Work Order ID 132259

Item Name: Fwd Crosstube - High 407

DRAWING NO. D407-667-145	TITLE CROSSTUBE ASS'Y (407 HIGH FWD)	REV. C	DART AEROSPACE LTD ENGINEERING ORDER		D.E.O. NO. D407-667-145-C-1	SHEET NO. SHEET 1 OF 1	SCALE NTS
DRAWN <i>q</i>	CHECKED <i>ASS</i>	MFG. APPR. <i>IS</i>	APPROVED <i>WD</i>		DE APPR. <i>##</i>		
DATE 11.07.15	DATE 11.07.22	DATE 11.07.22	DATE 11/07/22		DATE 11.07.21

DRAWING NO. D407-667-145	TITLE CROSSTUBE ASS'Y (407 HIGH FWD)	REV. C	DART AEROSPACE LTD ENGINEERING ORDER		D.E.O. NO. D407-667-145-C-2	SHEET NO. SHEET 1 OF 1	SCALE NTS
DRAWN AJS	CHECKED J	MFG. APPR. B	APPROVED AD	DE APPR. H	DATE 12.08.02	DATE 12.08.02	DATE 12.08.02

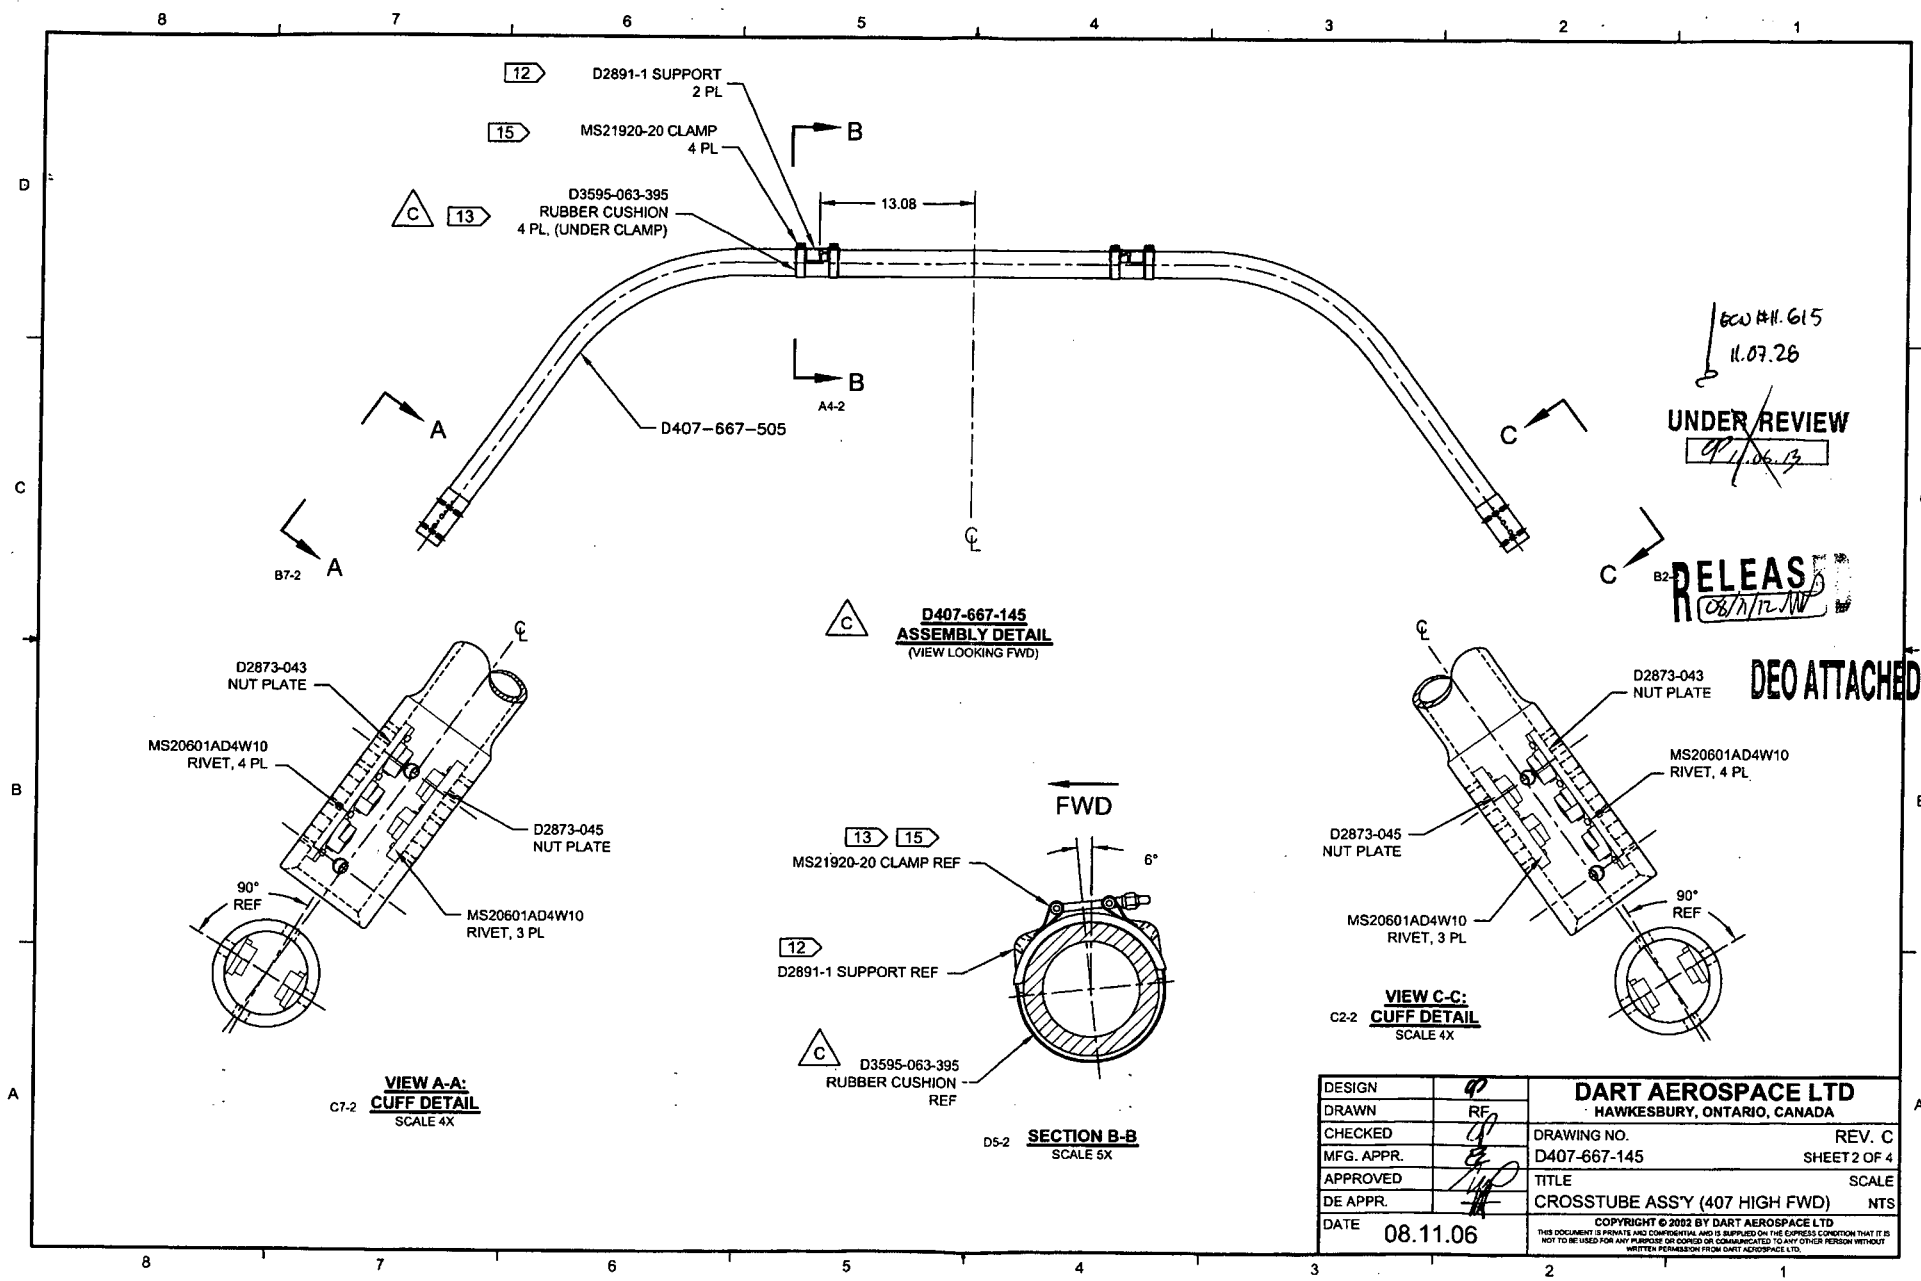
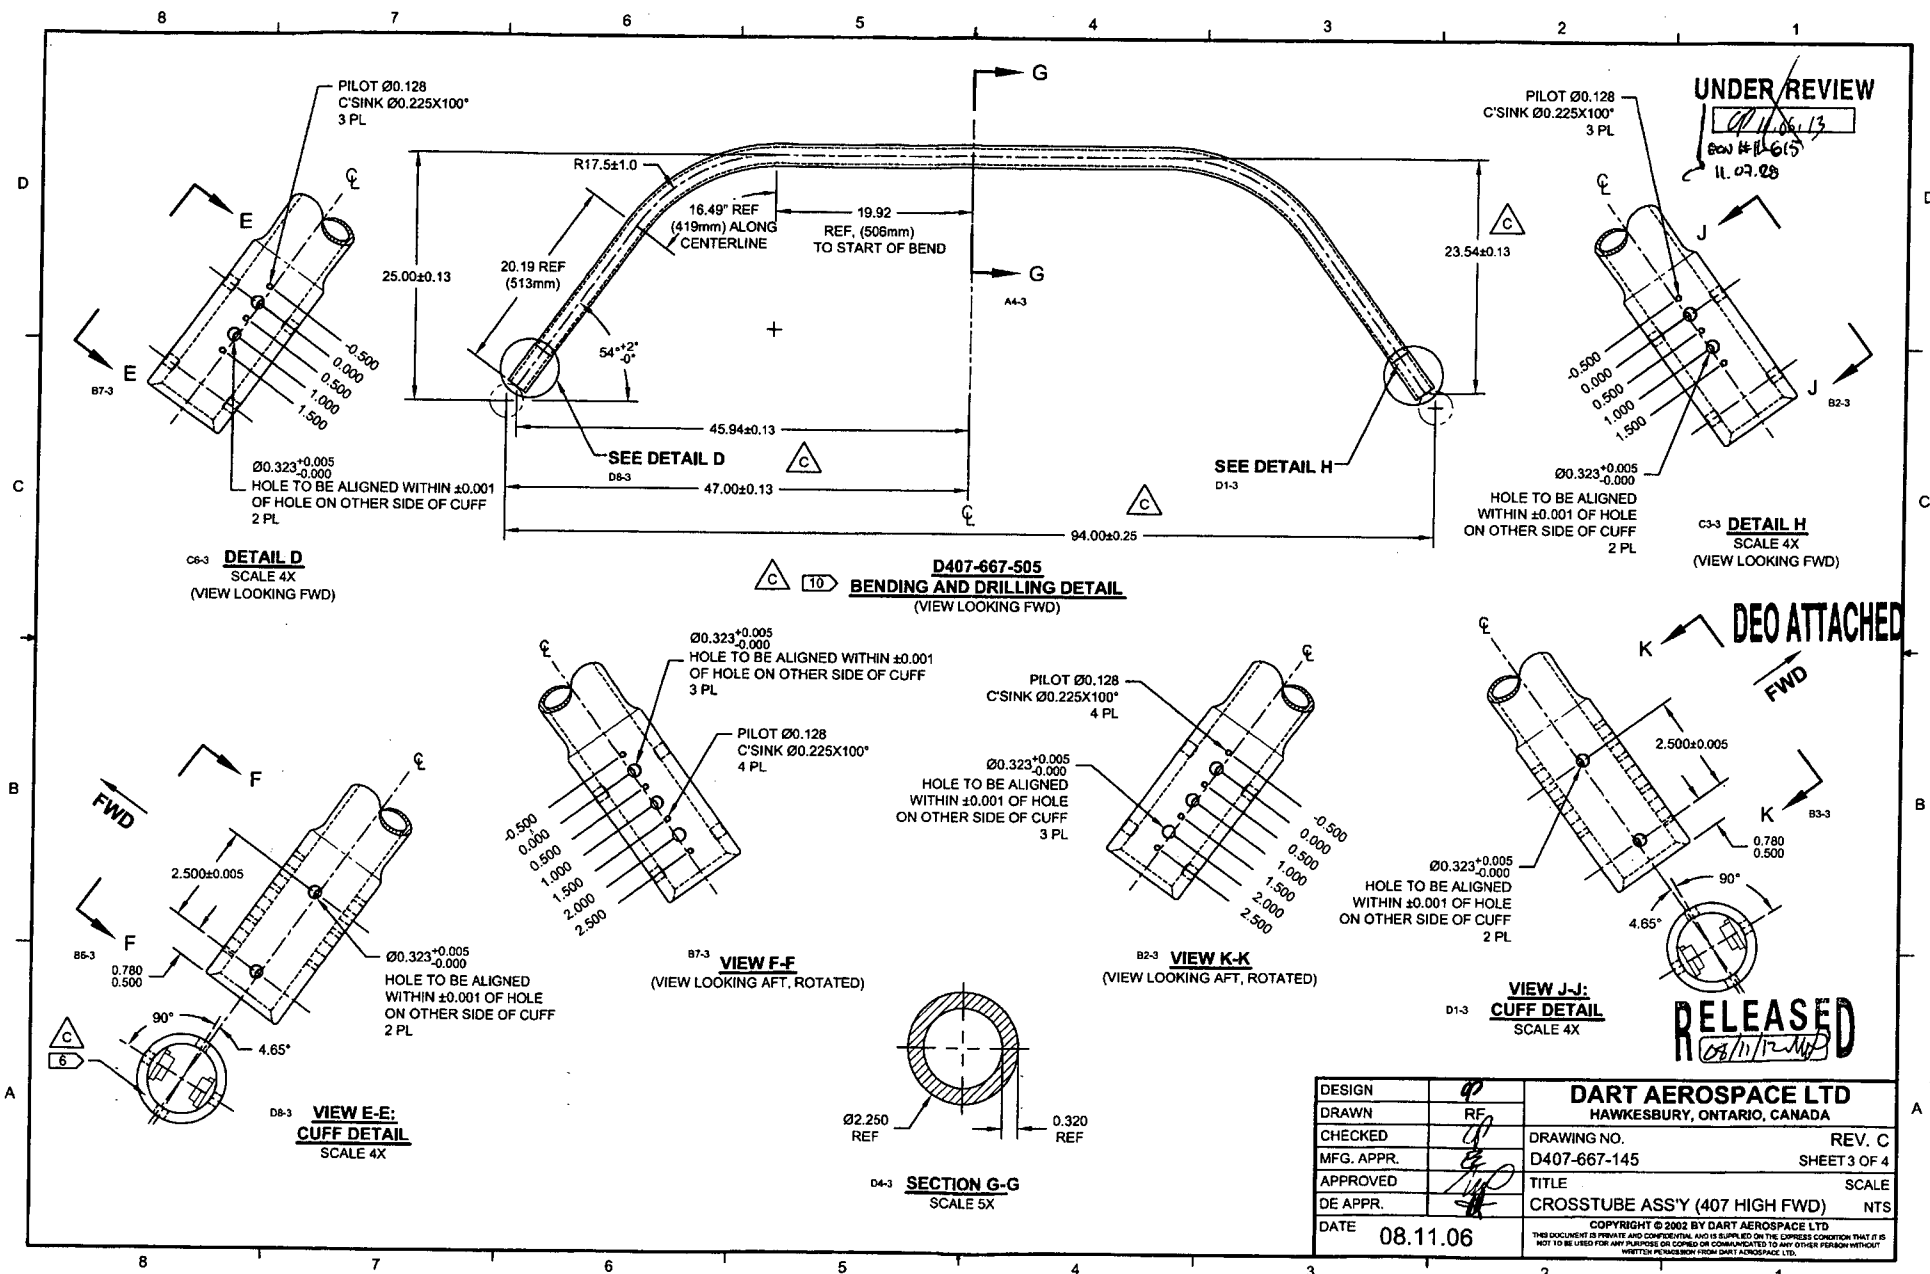
PURPOSE:

REPLACE MAGNOBOND WITH PROSEAL.

NOTE 12 & 15, SHEET 1 IS AMENDED AS FOLLOWS:

- 12) TO INSTALL D2891-1 SUPPORT: ABRASE MATING SURFACE OF SUPPORT AND CROSSTUBE WITH 180-GRIT SANDPAPER AND REMOVE RESIDUE WITH MEK (OR EQUIVALENT). APPLY A 0.04" TO 0.07" THICK LAYER OF PROSEAL 890 CLASS B-2 (OR AMS-S-8802 CLASS B-2) SEALANT TO MATING SURFACE OF SUPPORT.
- 15) TORQUE CLAMPS 80 TO 100 IN-LB. ENSURE AT LEAST 1.5 THREADS SHOWING IN SAFETY AND THAT NUT HAS NOT BOTTOMED-OUT AFTER TORQUING. **PRIOR TO PACKAGING, RE-CHECK TORQUE ON CLAMPS AFTER PROSEAL 890 SEALANT HAS CURED FOR 72 HOURS.**

DETAIL P
BONDING STRAP INSTALLATION 2 PL

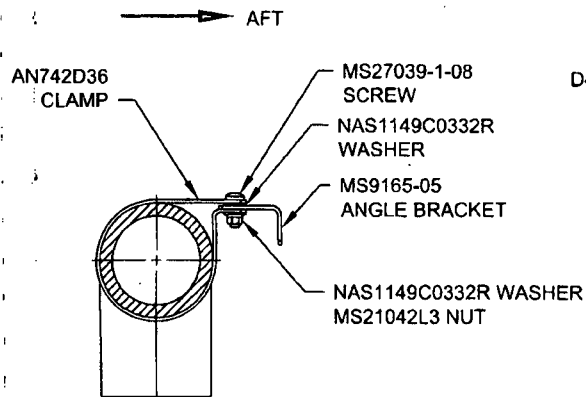
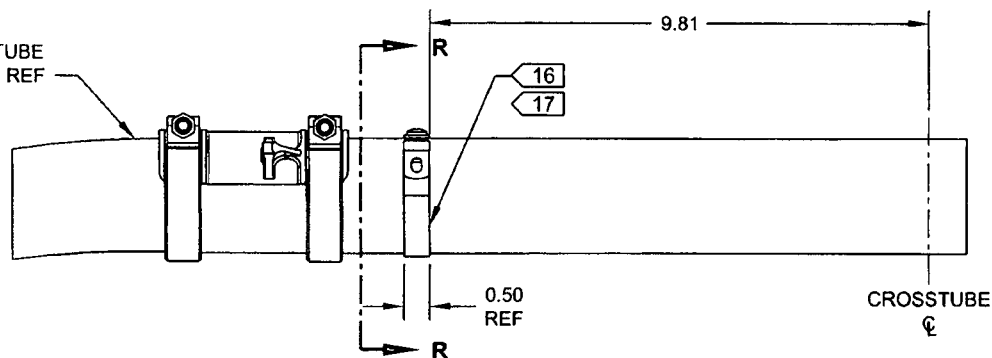
PURPOSE:

ADD ELECTRICAL GROUNDING STRAP

ITEM	QTY -145	PART NUMBER	DESCRIPTION
1	X	D407-667-145	CROSSTUBE ASSEMBLY (407 HIGH FWD)
⚡			
10	2	AN742D36	CLAMP
11	2	MS9165-05	ANGLE BRACKET
12	2	MS21042L3	NUT (OR MS21042-3)
13	2	MS27039-1-08	SCREW
14	4	NAS1149C0332R	WASHER (OR AN960C10L)

- 16) MASK AREA UNDER CLAMP PRIOR TO PAINTING
- 17) SEAL EDGES WHERE AN742D36 CLAMP MEETS WITH THE CROSSTUBE USING SIKAFLEX-241/-291 OR MIL-S-8802 CLASS B2 OR PROSEAL 890 SEALANT
- 18) PERFORM RESISTANCE CHECK TO ENSURE MAX RESISTANCE IS 10 MILLIOHMS
